TENNESSEE VALLEY AUTHORITY

In the Matter of the Application of) Docket Nos. 50-390
Tennessee Valley Authority) 50-391

In my letter to you dated June 4, 1982, TVA committed to provide modifications to protect the diesel generator from degraded operation due to a tornado-generated missile impacting the diesel generator exhaust. The NRC in the Watts Bar Nuclear Plant Safety Evaluation Report indicated this was acceptable pending review of the details of the modification. Enclosed is a brief report describing the design associated with this modification and related sketches. This information should resolve confirmatory item 7.

WATTS BAR NUCLEAR PLANT UNITS 1 AND 2 TORNADO MISSILE PROTECTION FOR DIESEL GENERATOR EXHAUSTS

SECTION A3-A3
TYPICAL SECTION THRU
MISSILE SHIELD HOOD
NORTH WALL

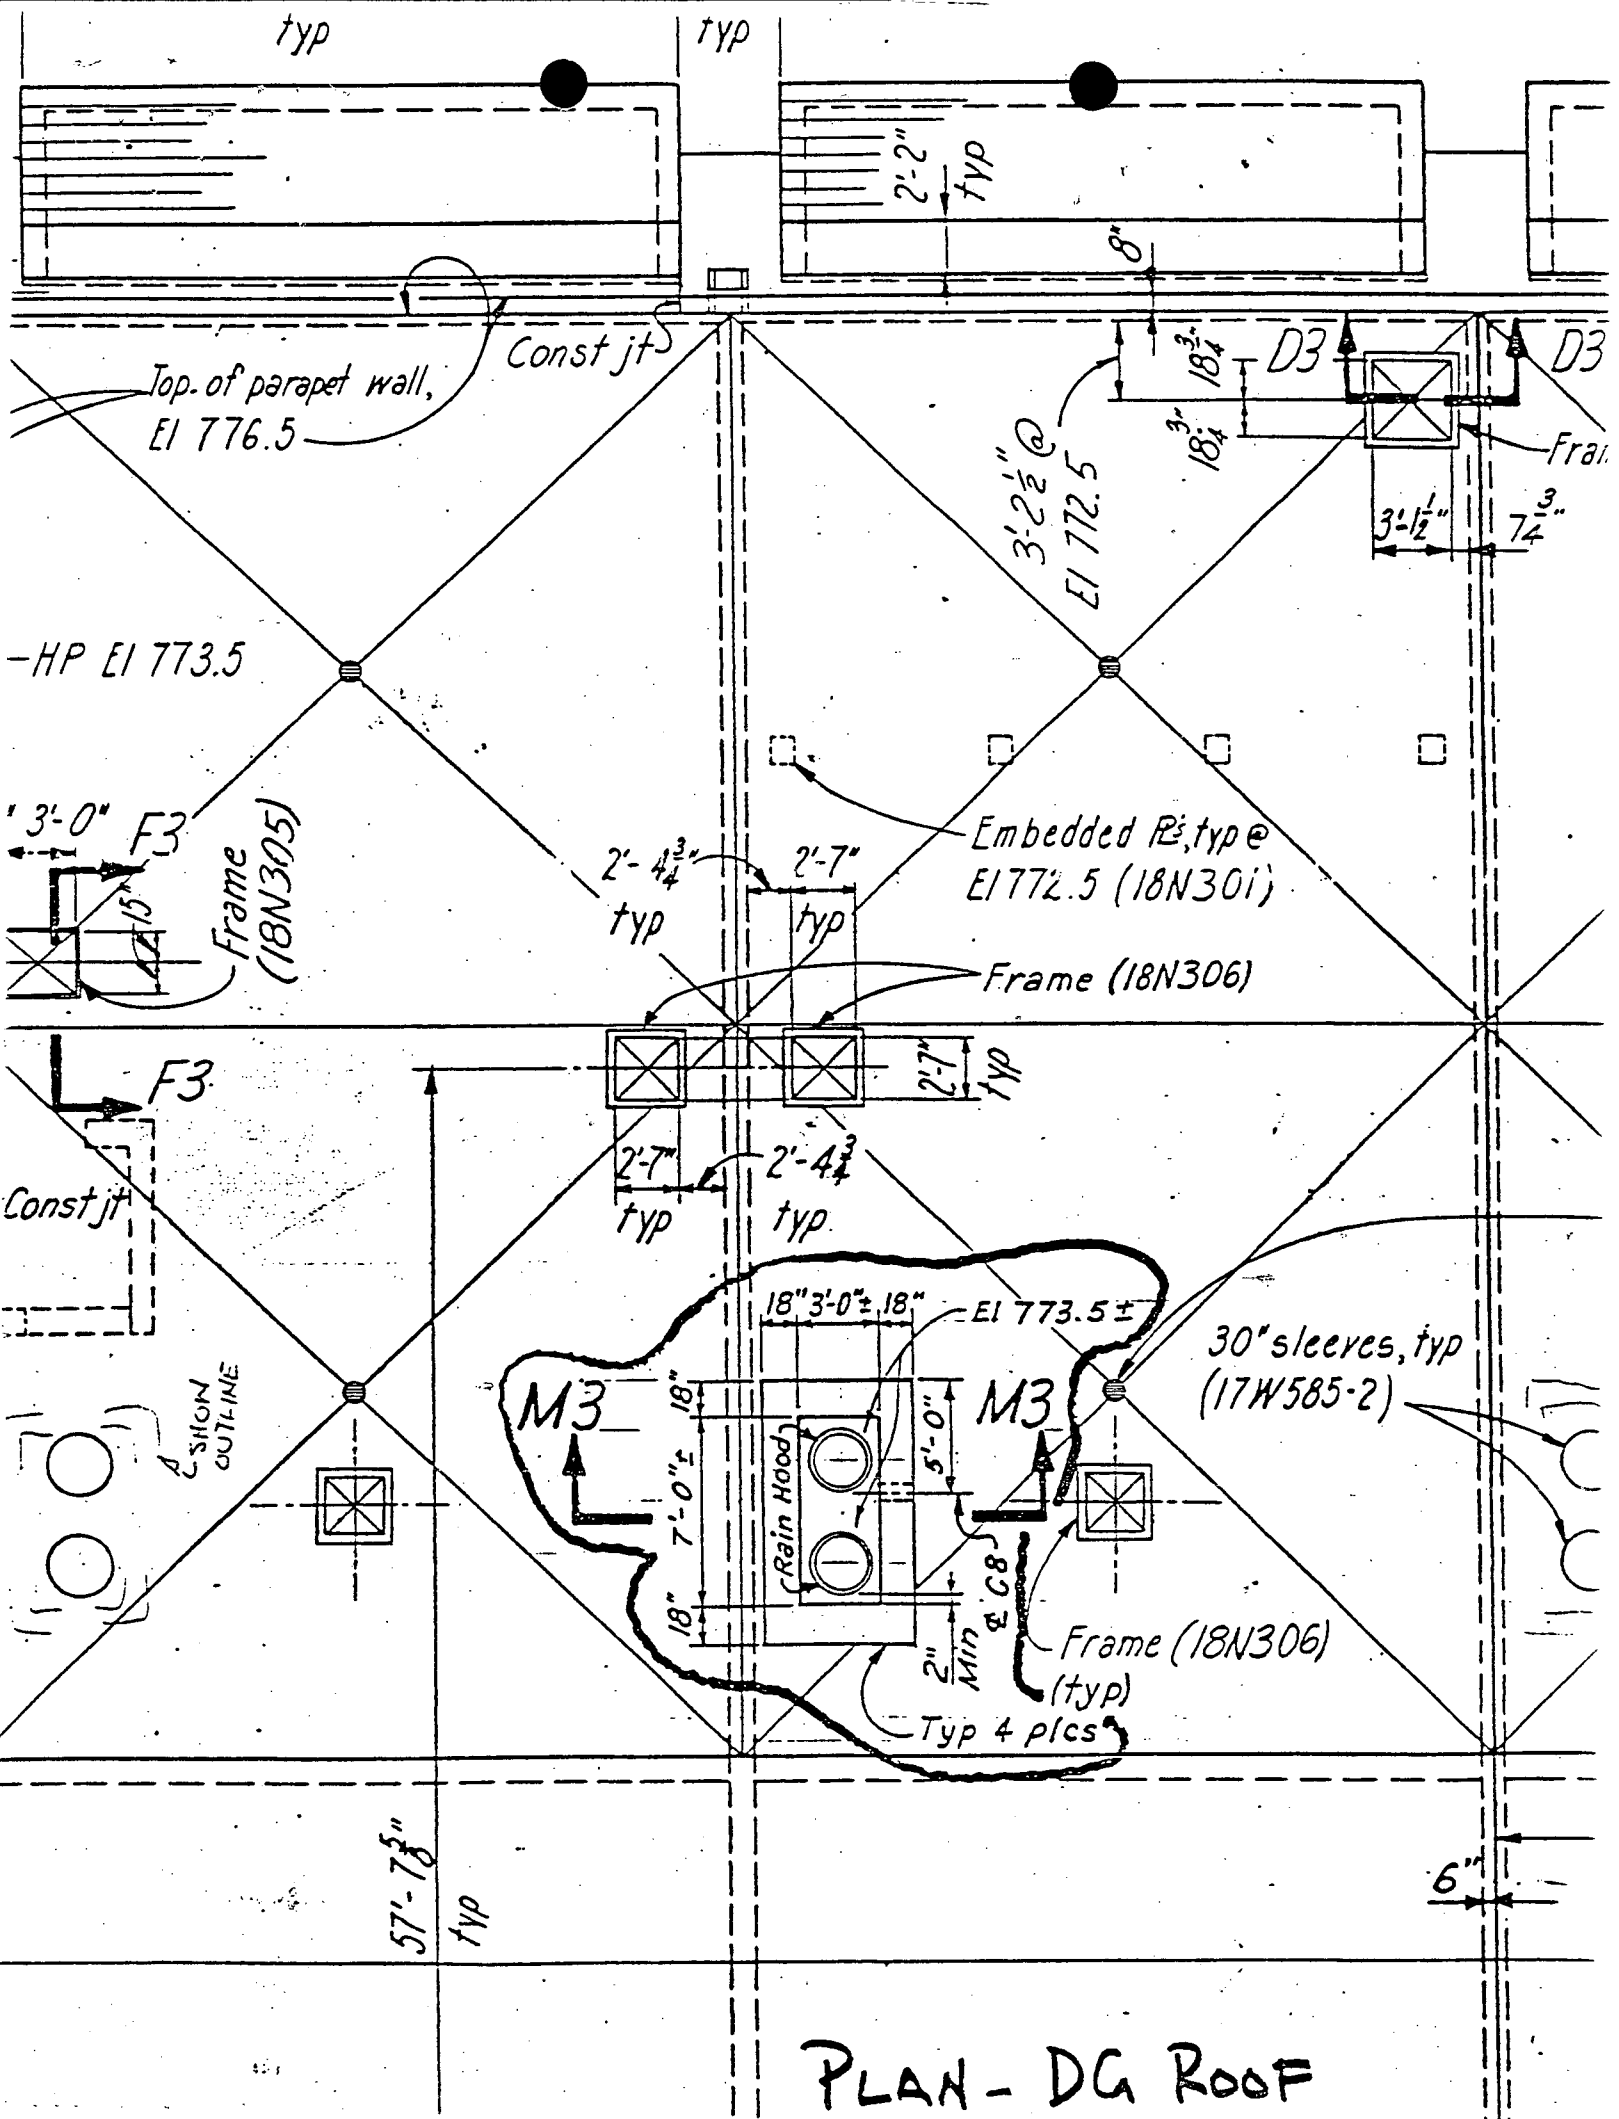
The attached sketches show the reinforced concrete curb around the diesel exhaust stacks to provide protection from tornado-generated missiles.

The curb is 18 inches thick and extends 12 inches above the top of the exhaust stacks. The curb is to protect the exhausts from a one inch diameter rebar impacting at 210 fps (see missile A5 of spectrum A in WBN FSAR, section 3.5.1.4). The use of missile spectrum A is appropriate since that spectrum was used for the original design of the diesel generator building (DGB). The testing program of reference 1* indicated that an 18 inch thick barrier would stop the one inch diameter rod at impact velocities in excess of 300 fps with no backface scabbing. Therefore, the exhaust stacks will be adequately protected from tornado missiles by the curb.

The 30 inch diameter sleeve and the sheet metal rain hood originally provided to prevent the entry of rainwater into the DGB will be left in place. A drain is provided in the curb to prevent the accumulation of rainwater.
